ADDENDUM NO. 1

Bid No. 2026/27 – 1FA

Lease of Relocatable Buildings

Request for Information (RFI)
Bid No. 2026/27 – 1FA
Lease of Relocatable Buildings

36 x 40 CLASSROOM	ITEM B
-------------------	--------

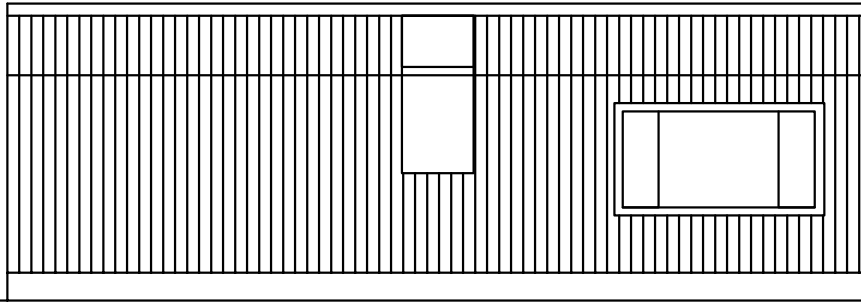
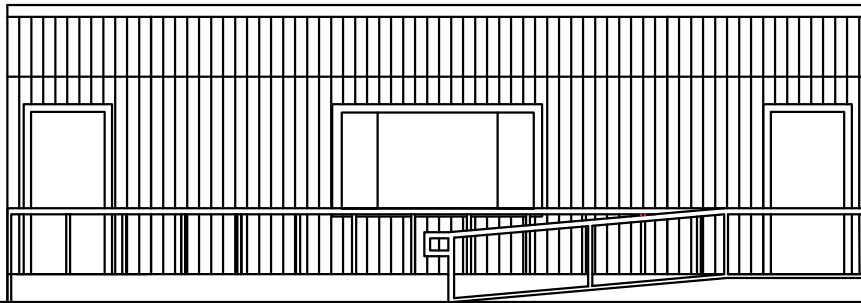
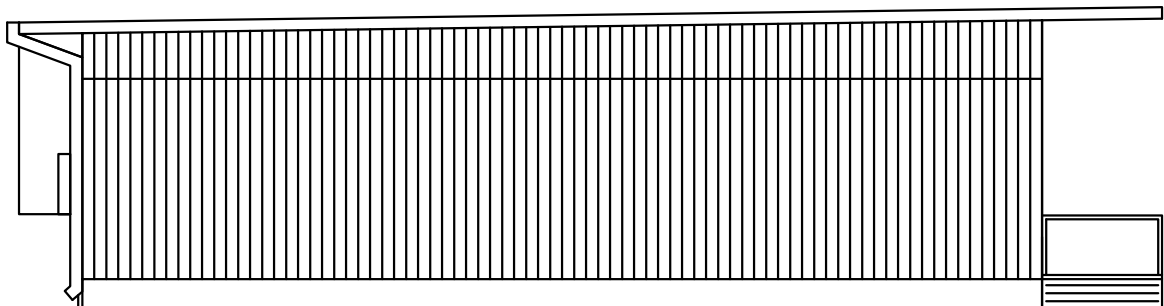
1.25 Q: Can both exterior doors be on the 36' side underneath the 5' overhang?

A: See revised Relocatable Building Floor Plan – Item B.

24 x 40 DAYCARE W/ RR	ITEM H
------------------------------	---------------

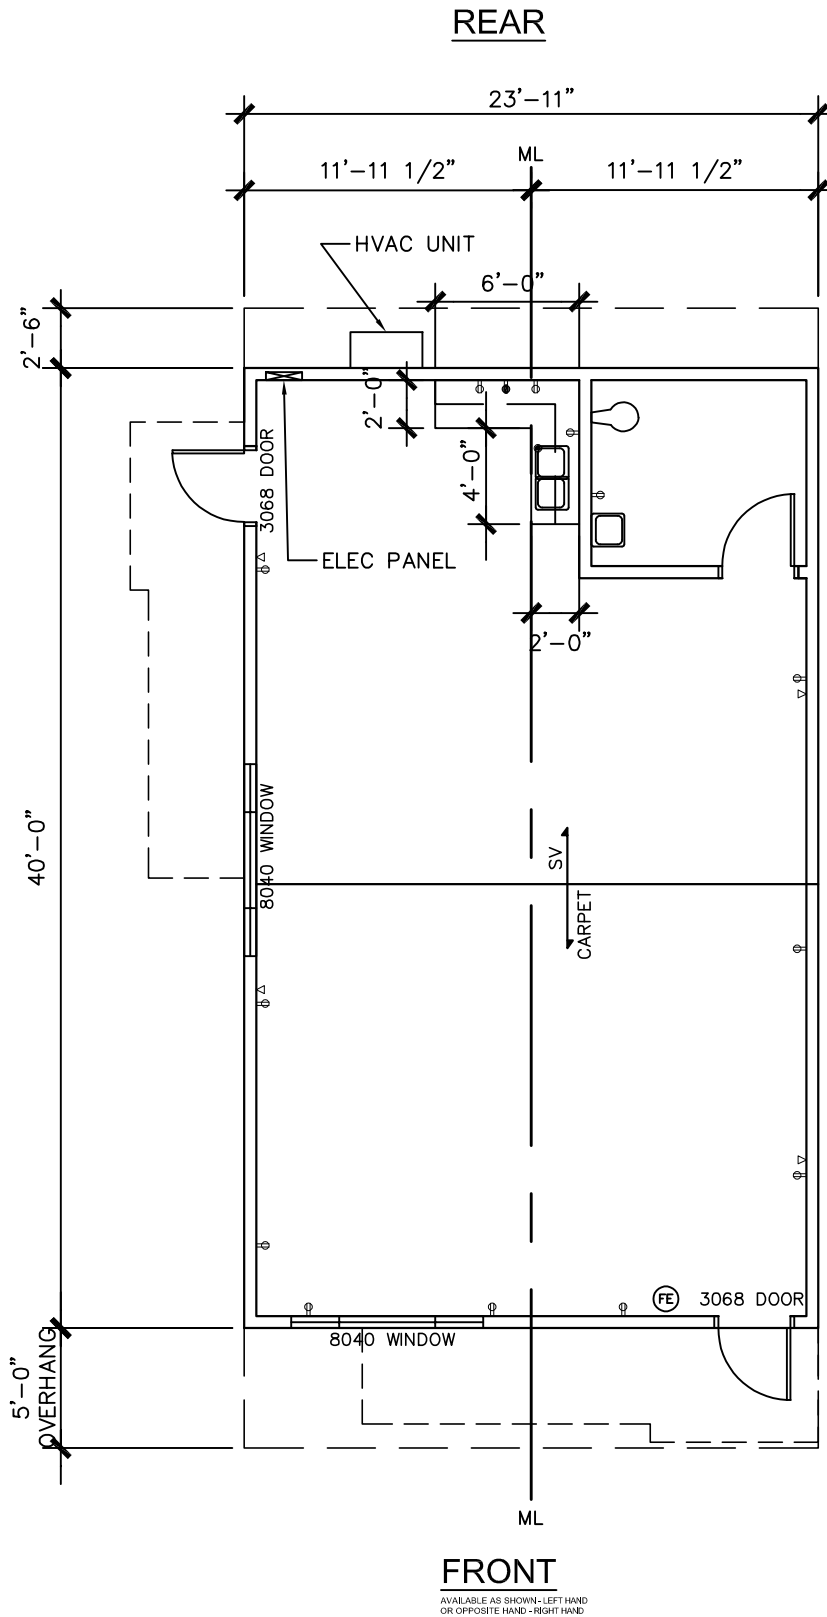
1.28 Q: Item H – Will the district confirm the linear feet of cabinets?

A: Contractor shall provide ten (10) Lineal Feet of upper and lower cabinets. See revised Relocatable Building Floor Plan – Item H.
